Office Action Summary

10/816,780

DETAILED ACTION

5,667,523

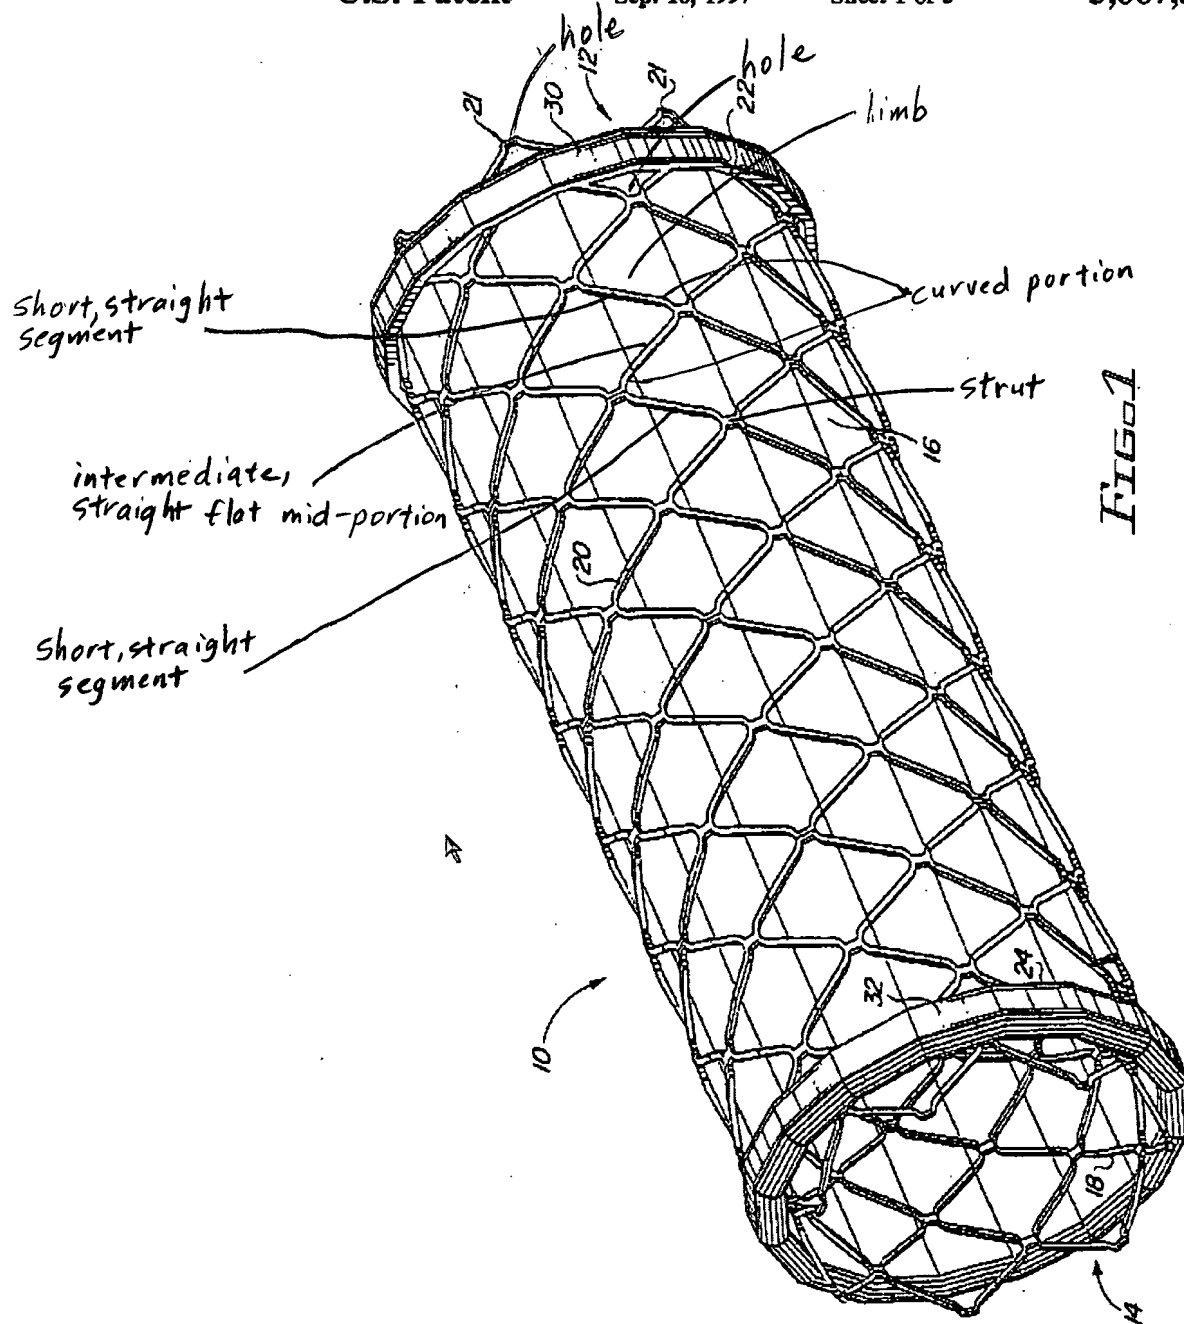
2. Claims 12-18, 24, and 25 are rejected under 35 U.S.C. 102(e) as being anticipated by Bynon et al. (5,667,523). Bynon et al. disclose, at least in figure 1, a limb or a stent comprising at least one limb having a cross sectional profile in which at least one segment is flat and straight, where each limb is comprised of two curved portions having opposite direction of curvature, an intermediate straight, flat mid-portion connecting the two curved portions, and short straight segment at each end; where the intermediate straight, flat mid portion is angled with respect to the short, straight segments at each end in an expanded state, where the stent has been provided with at least one strut in order to augment expansion, where the stent has been provided with a multiplicity of struts to supplement each of the limbs, where the stent comprises a multiplicity of identical limbs or wires in order form a cylindrical structure, where the overall length of the stent is a multiple of the overall diameter of the cylindrical structure, and where the end of at least one limb is provided with a hole (at 21 or a trapezoidal

slot). See the yellow-shaded regions in the figure below for an illustration of the abovementioned limitations.

FIG. 2

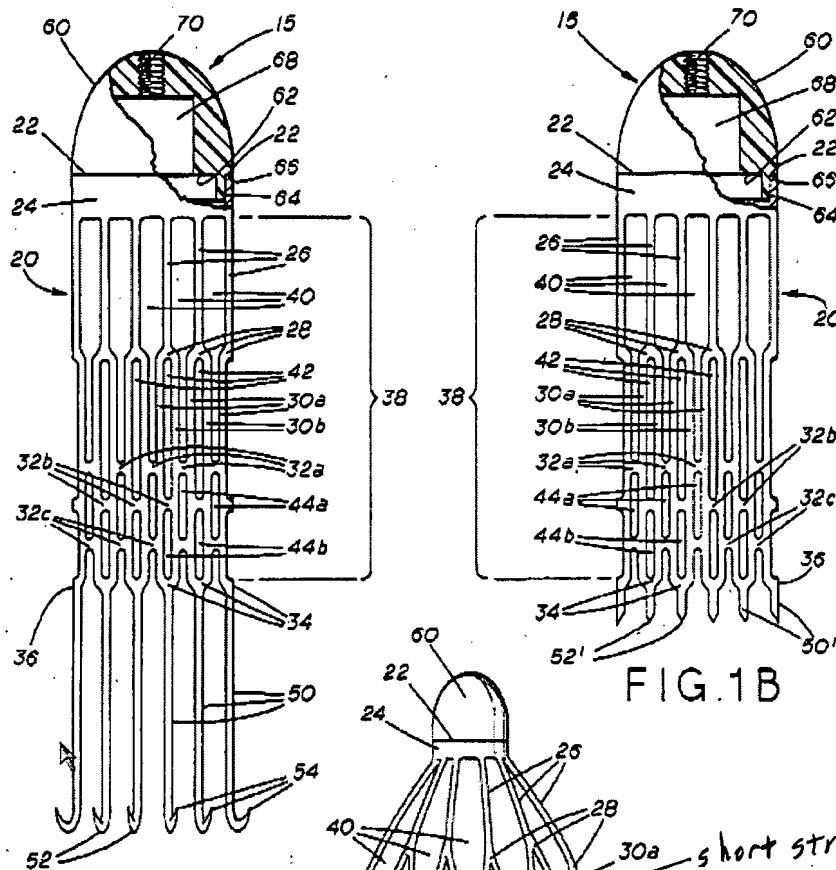
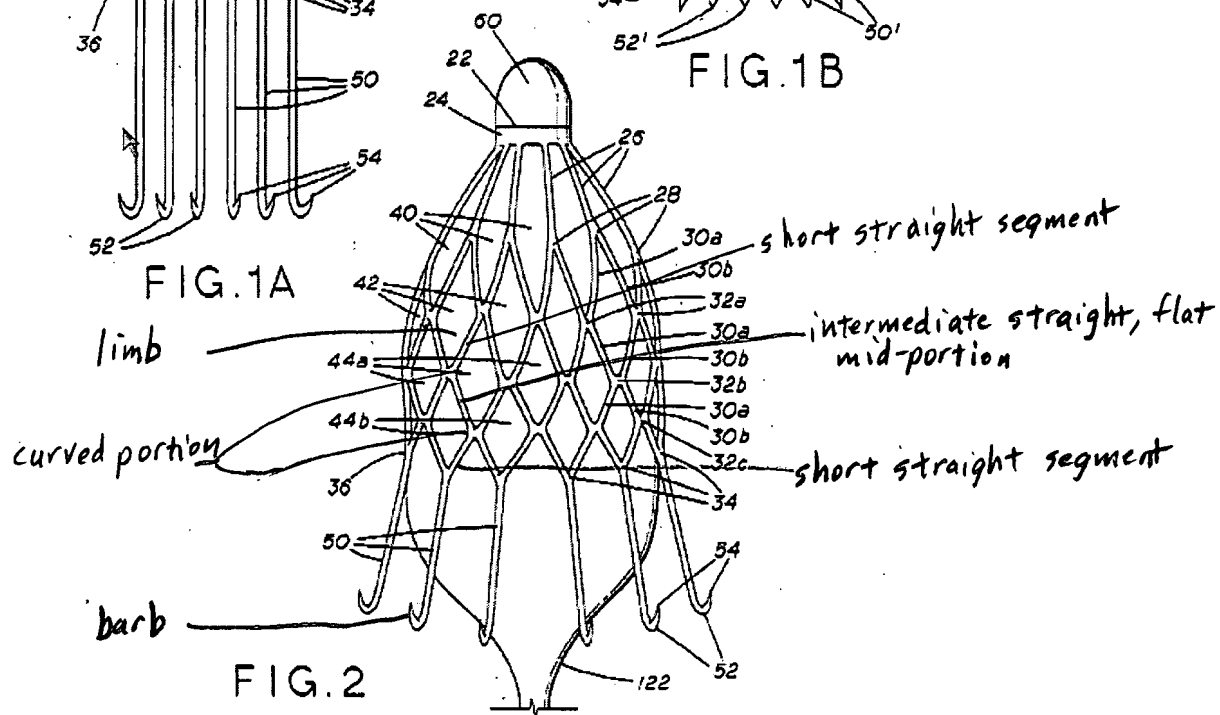
3. Claim 22 is rejected under 35 U.S.C. 102(b) as being anticipated by Palmaz (4,793,348). Palmaz discloses, at least in figure 2, a stent (20) comprising at least one limb having a cross-sectional profile in which one segment is flat and straight, where each limb is comprised of two curved portions having opposite directions of curvature, an intermediate straight, flat mid portion connecting the two curved portions, and short straight segments at each end, where the end of each limb has been provide with a barb (54). See the yellow-shaded region in the figure below for an illustration of the abovementioned limitations.
